Technical Bulletin

Bulletin: Floatfix.doc

To all Elite and Rebel Builders:

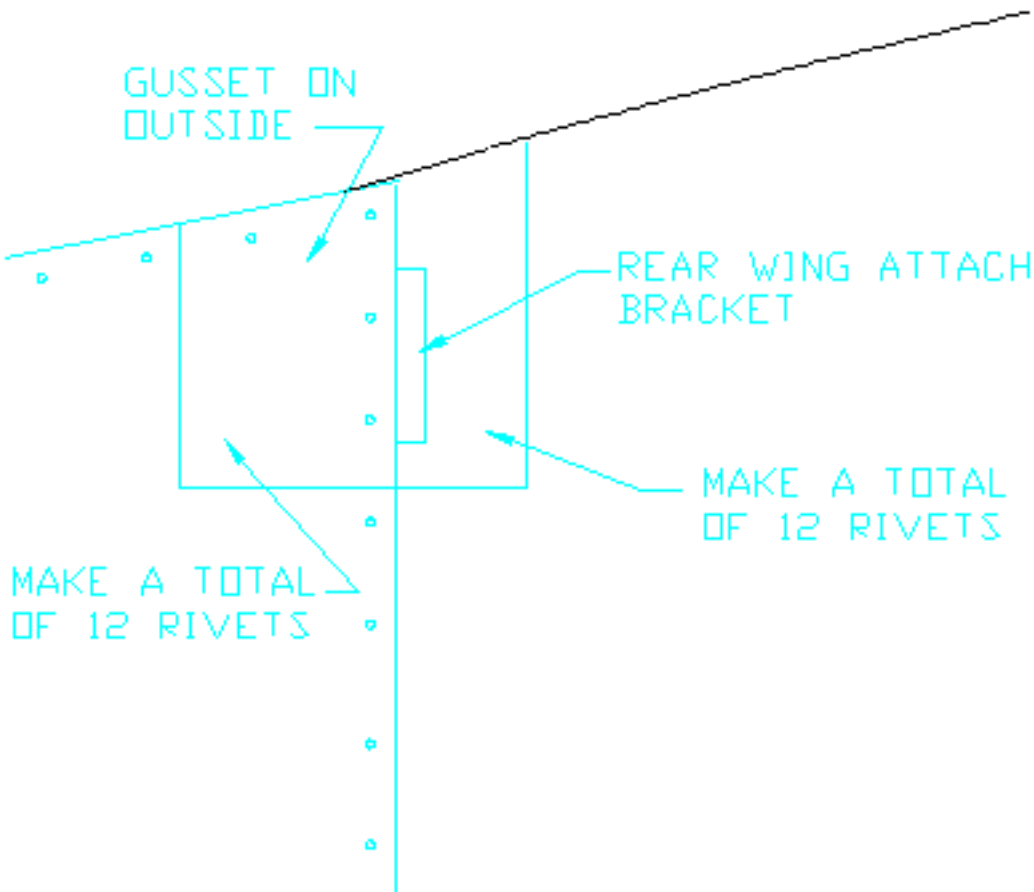
It has come to our attention that aircraft on floats, especially those that put on the larger engines and do not move the firewall back, have developed small cracks on the firewall around the top engine mounts. Also there was slight deformation in the skins around the top of the door posts causing the rivets to shear.

1) Firewall: On the firewall you will need to place a channel across the top between the two engine mounts. A 2" piece of channel should be used to accomplish this. On the existing firewall there are two pieces of witches hat section (FUS-12) that are on the front and back, therefore the new channel must be installed in two pieces with a 6" overlap. One piece of the channel will go on the back of the firewall sandwiched between the top engine mount bracket and the firewall. The other piece will go on the front of the firewall between the engine mount and the firewall. There are already existing parts in this area (dashboard brace, etc.) so you may need to stagger the overlap to one side or the other to accommodate them. Use a nominal 1" rivet spacing to attach the channel and a 3/4" rivet spacing on the overlap.

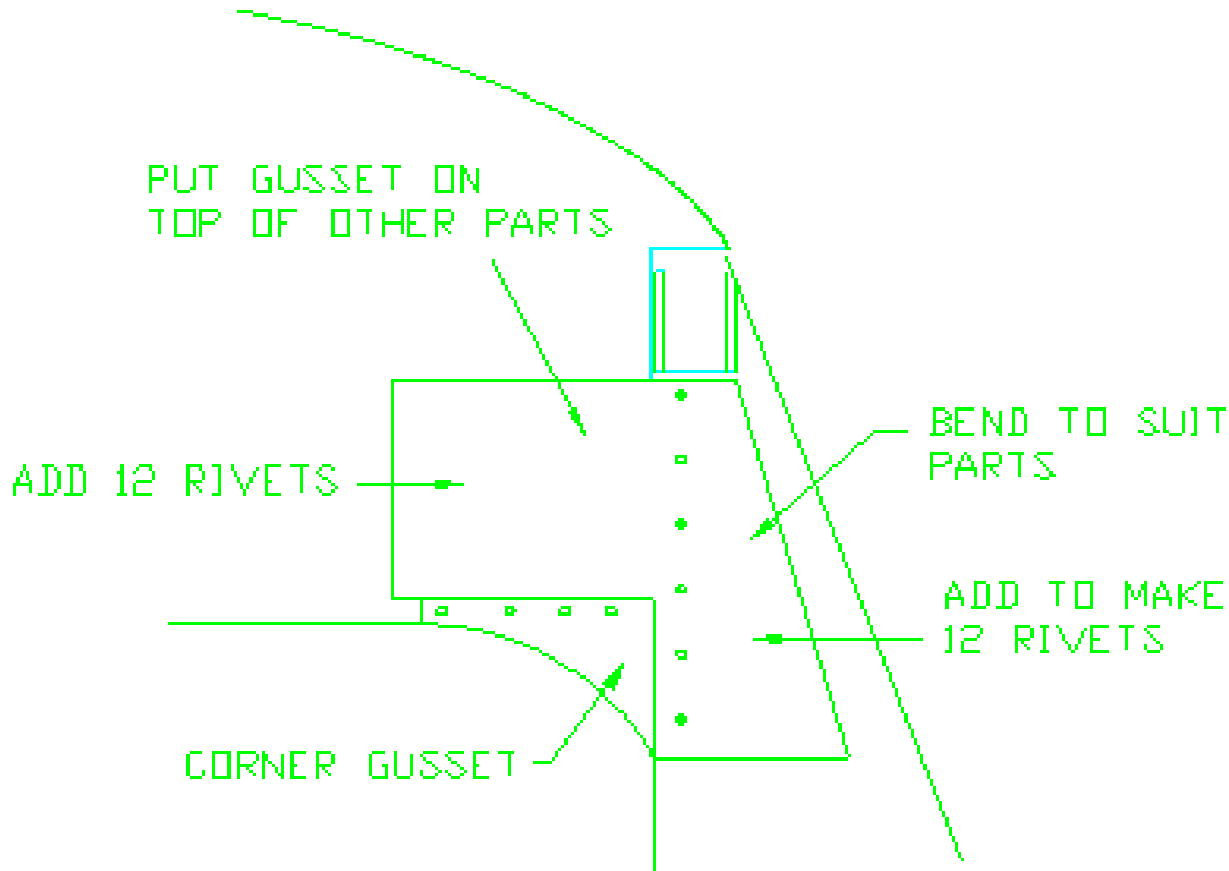
2) Door Posts: .032" doublers are needed on the top front and rear door post. See figures for the locations and approximate sizes of the doublers. Add rivets so that you get a total of twelve rivets on each side of the overlap on each doubler.
